**ADDENDUM NO. 3**  
**GEORGETOWN ELEMENTARY SCHOOL**  
**CLASSROOM & KITCHEN ADDITIONS**  
Georgetown, Delaware 19947

May 27, 2015

The documents for the above referenced project, Project Manual, dated March 2, 2015 and Drawings, dated April 10, 2015, and subsequently issued addenda are amended as follows:

E302

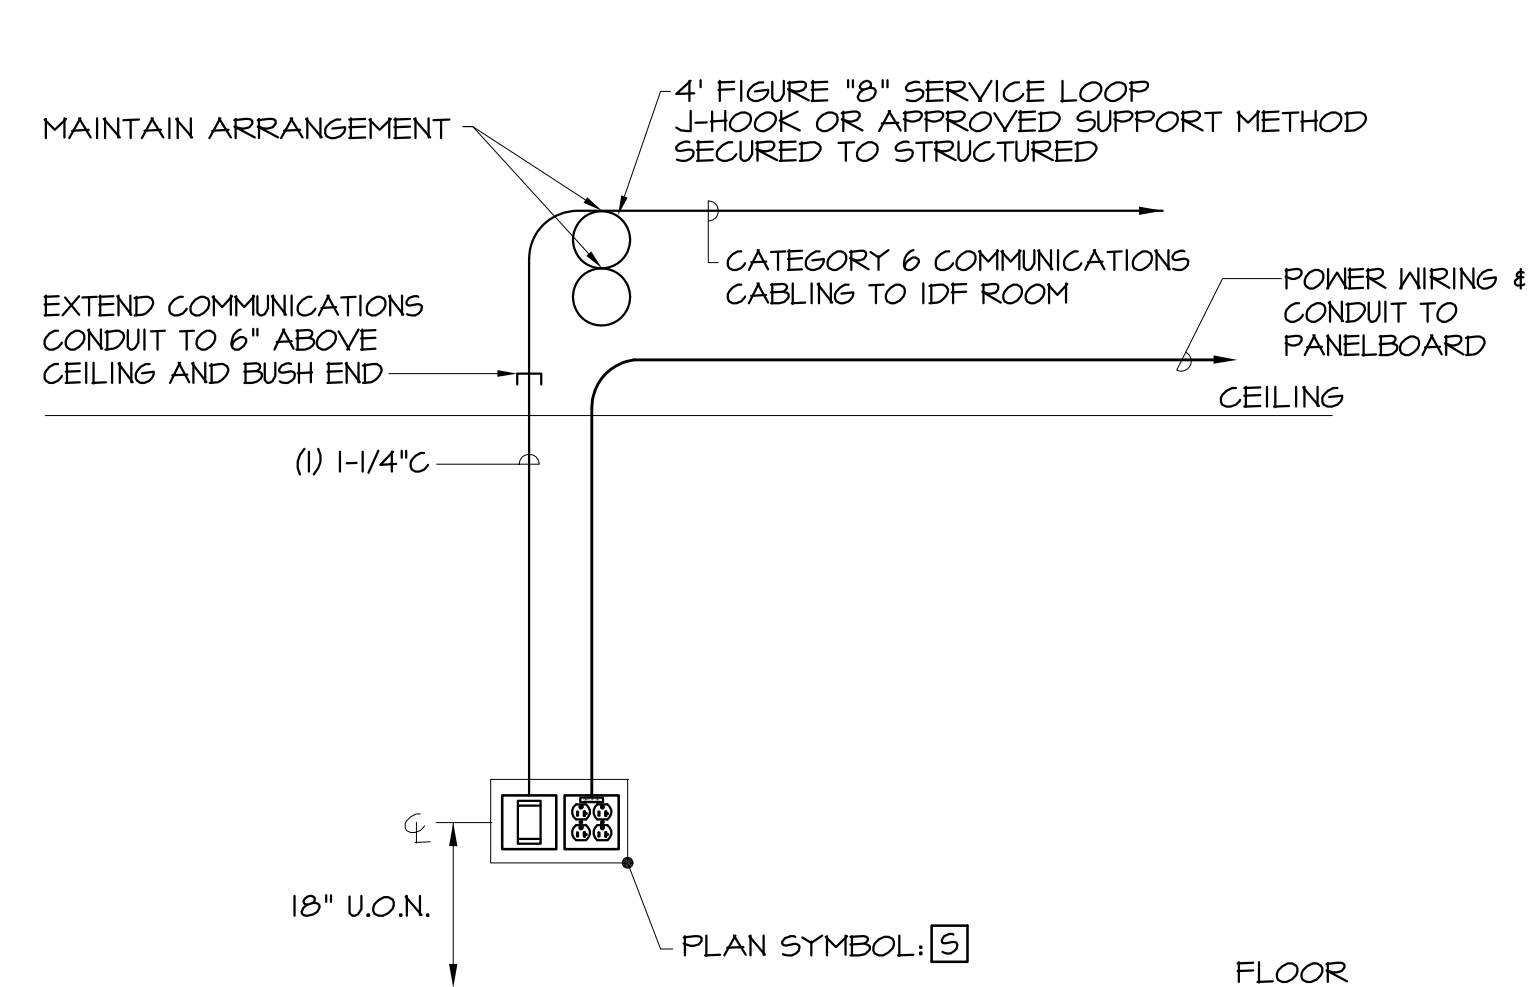
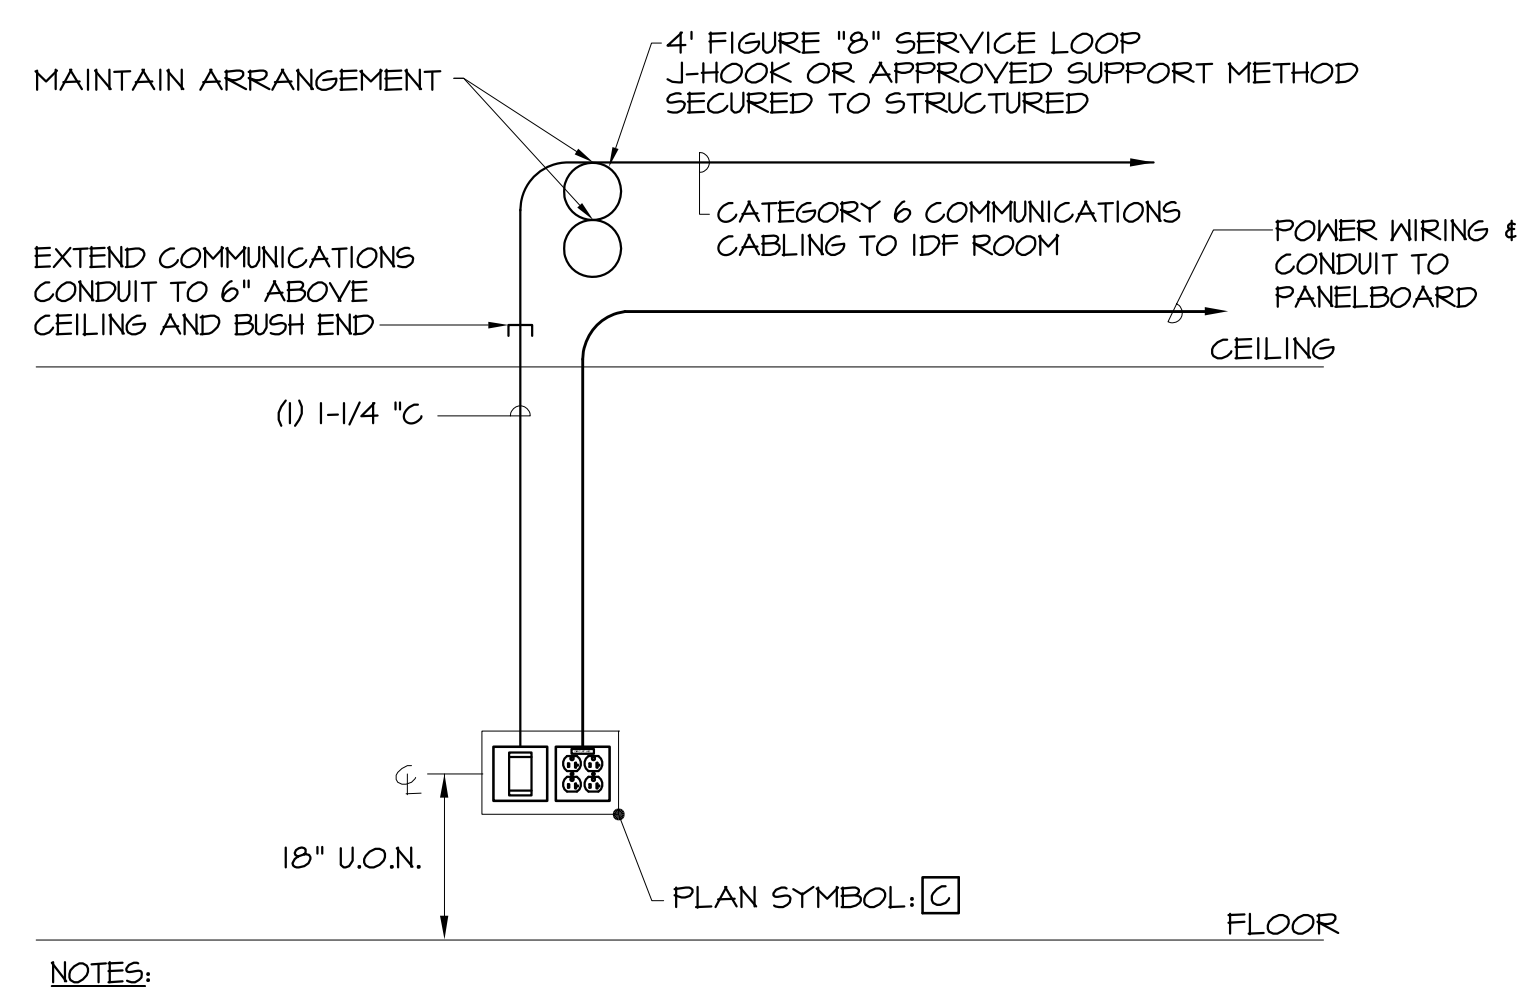
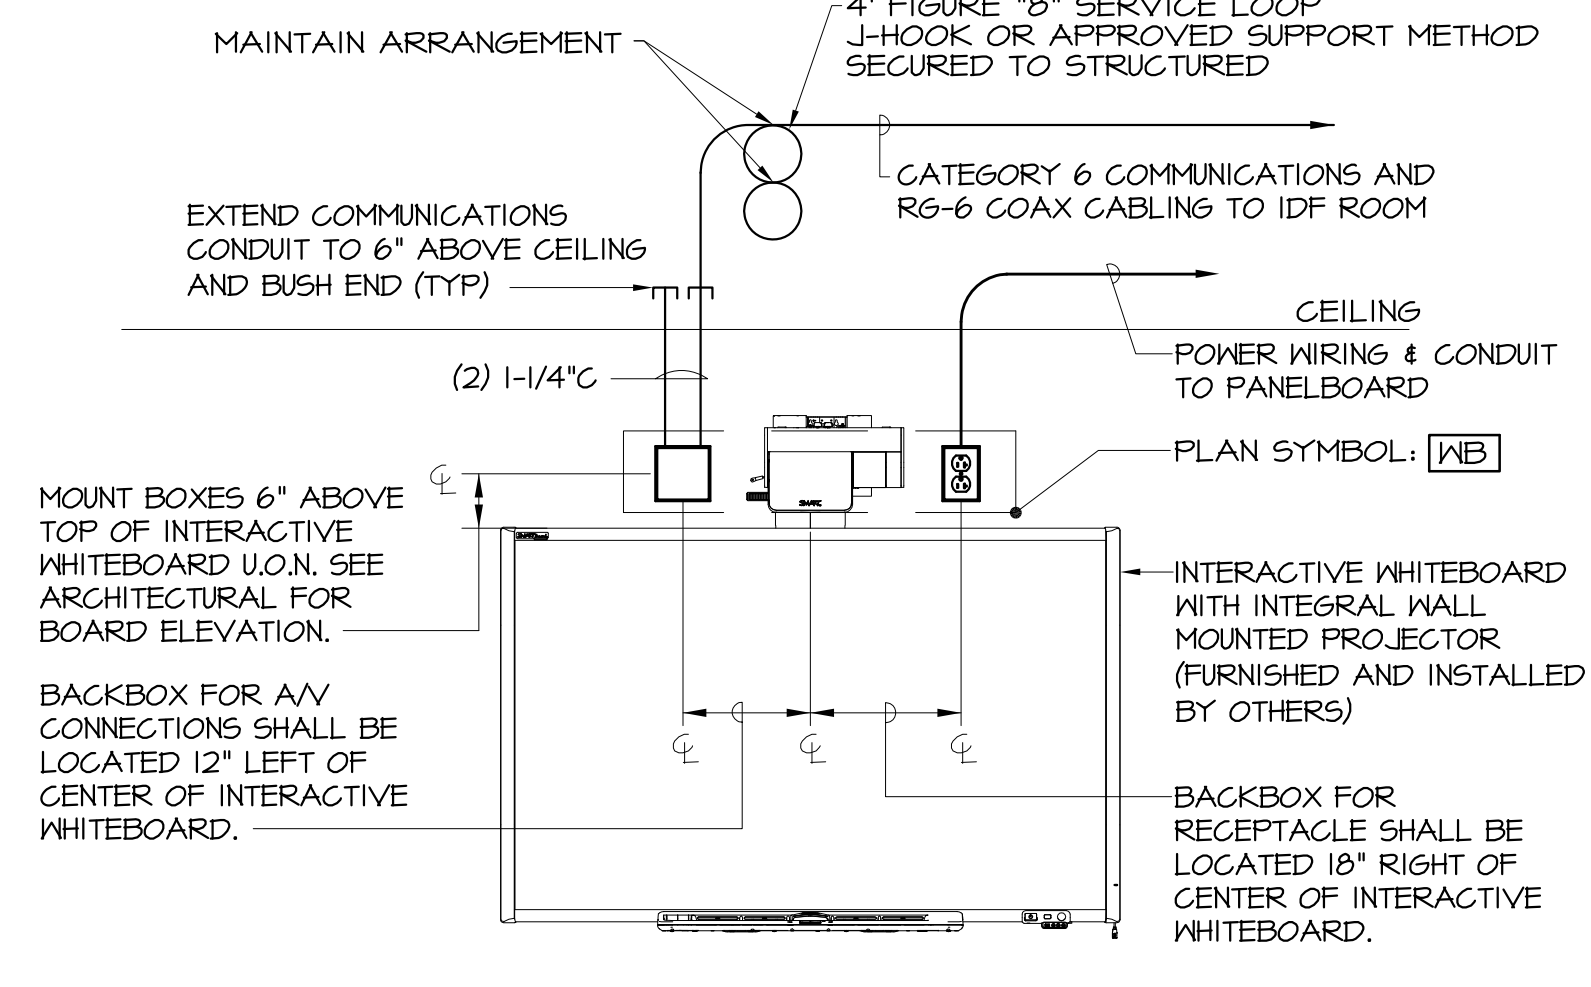
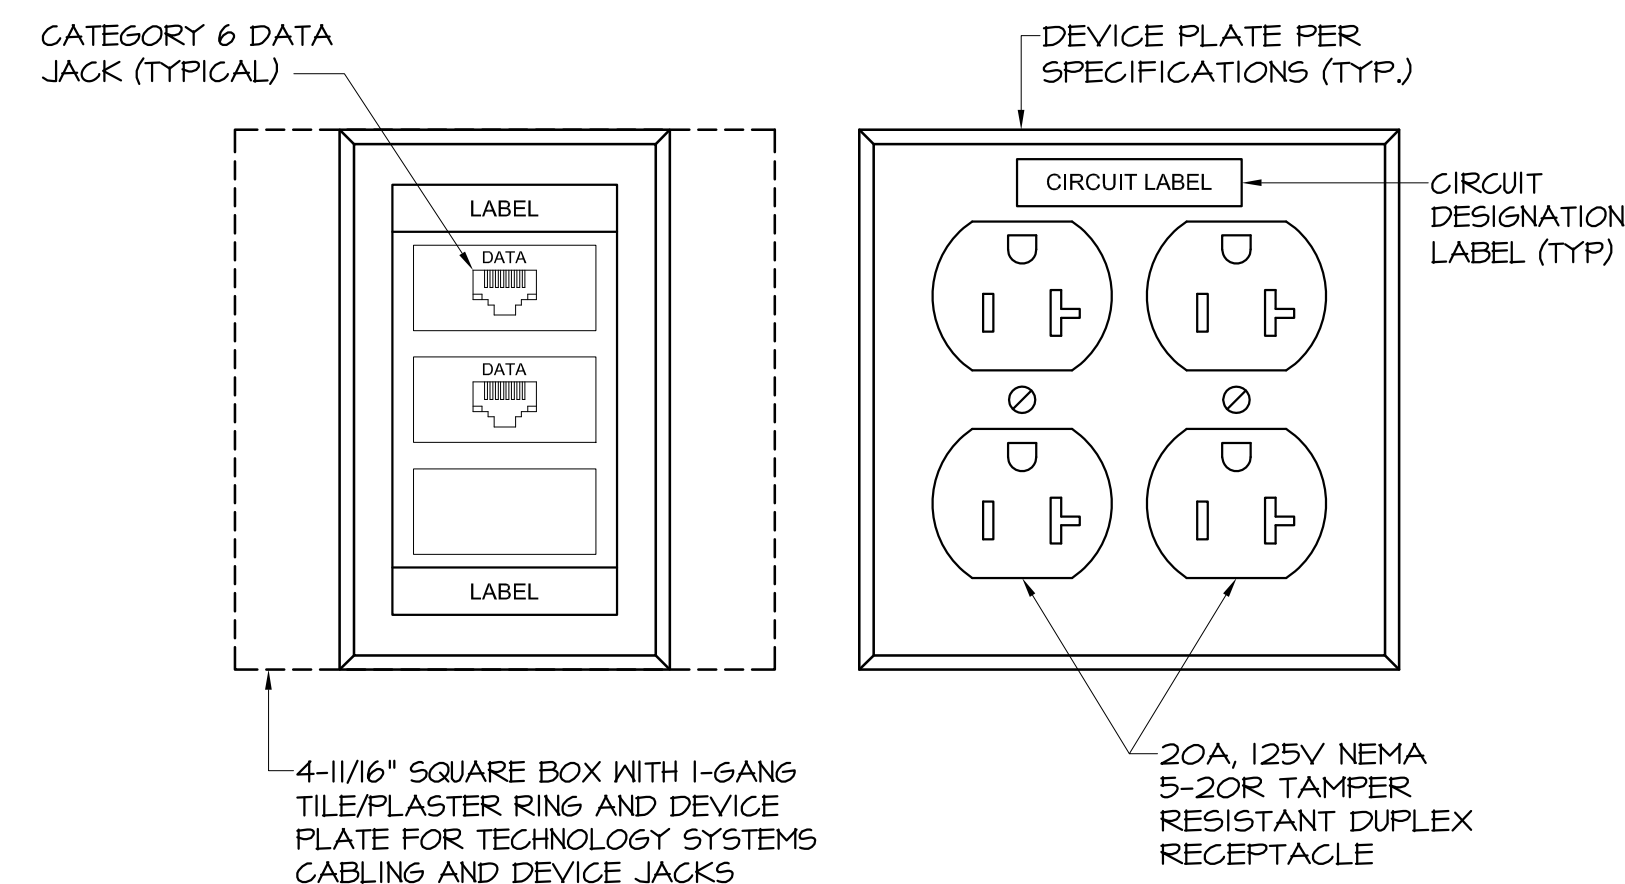
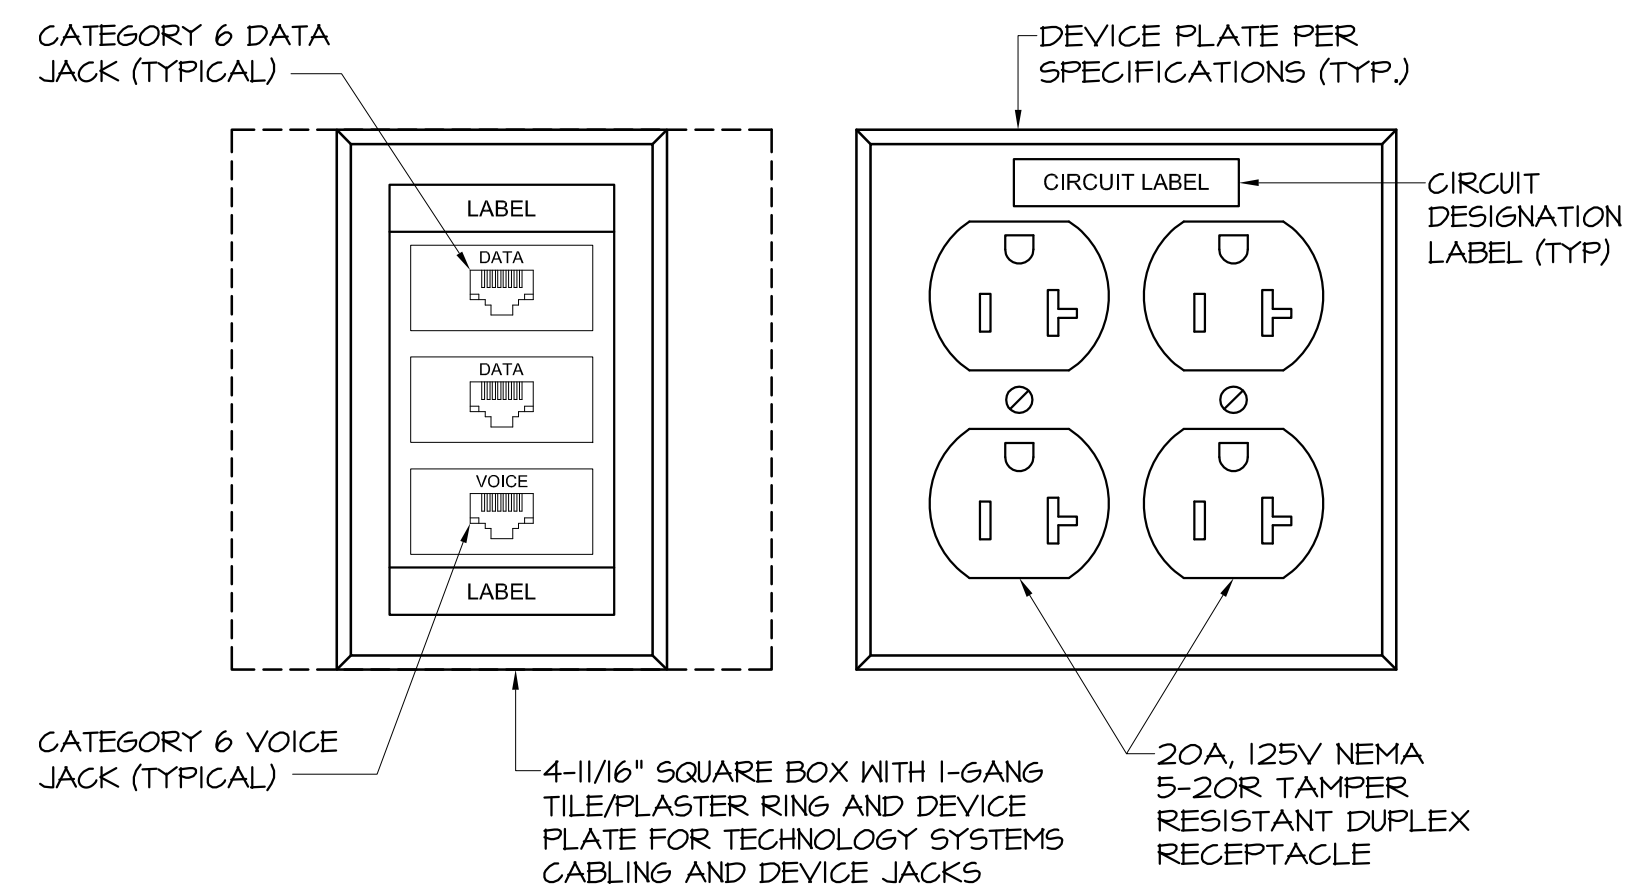
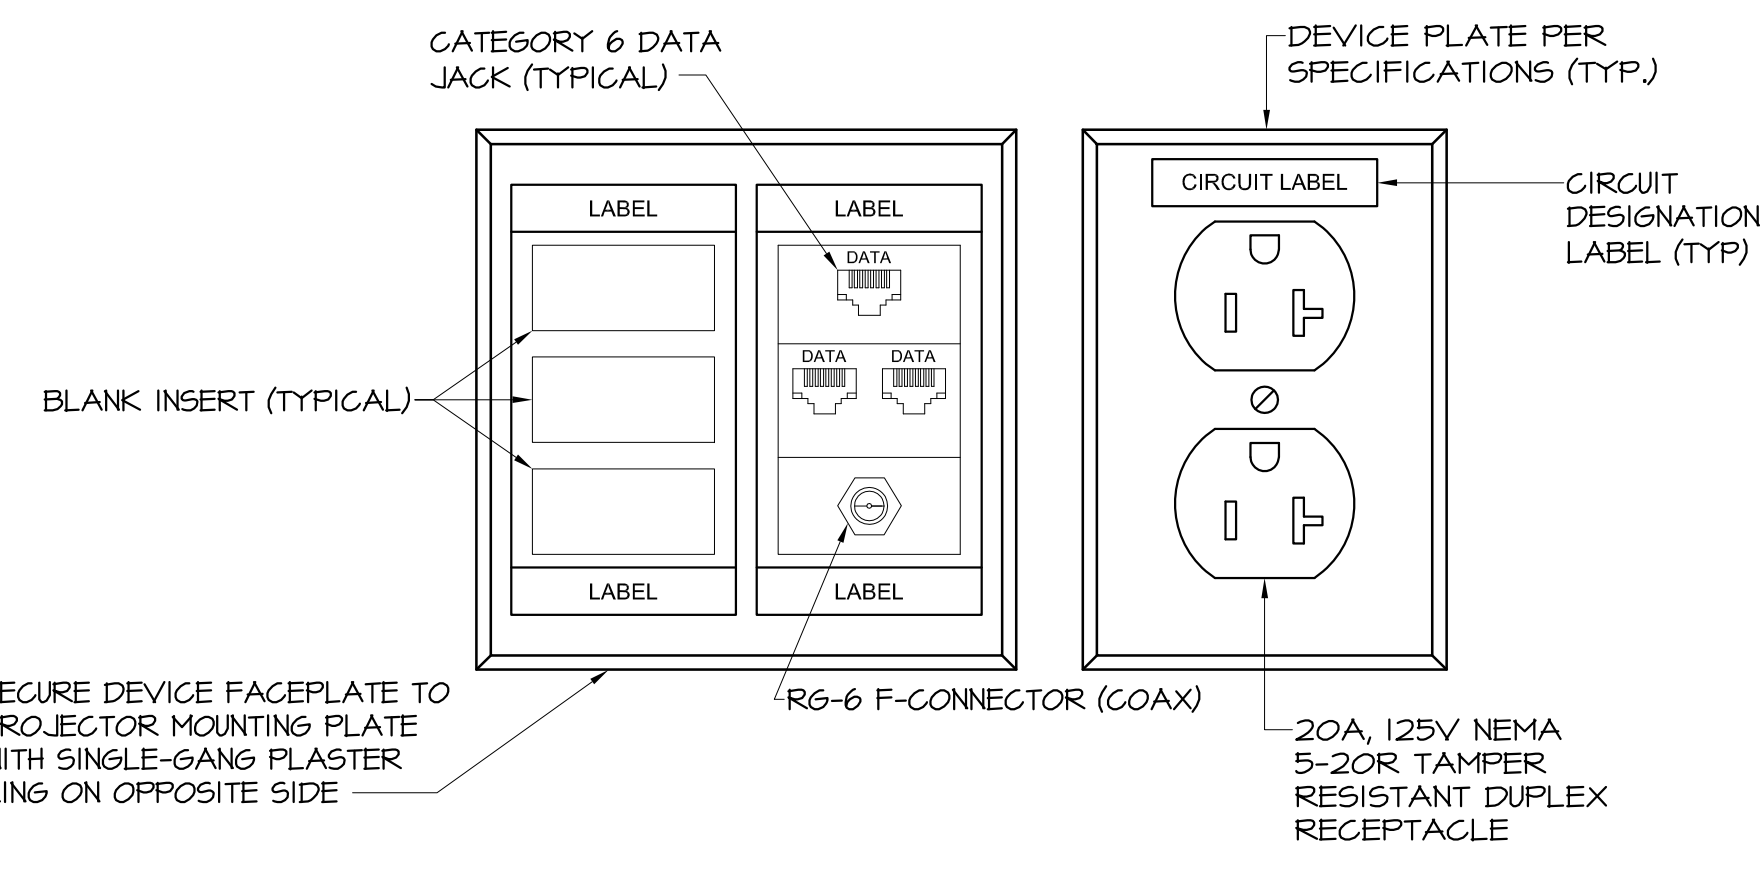
- 27. E302 – Details Electrical:
  - a. REPLACE Drawing E302 in its entirety with revised Drawing E302. Changes made to this sheet are based on the owner directed changes to the technology drop locations and quantities.
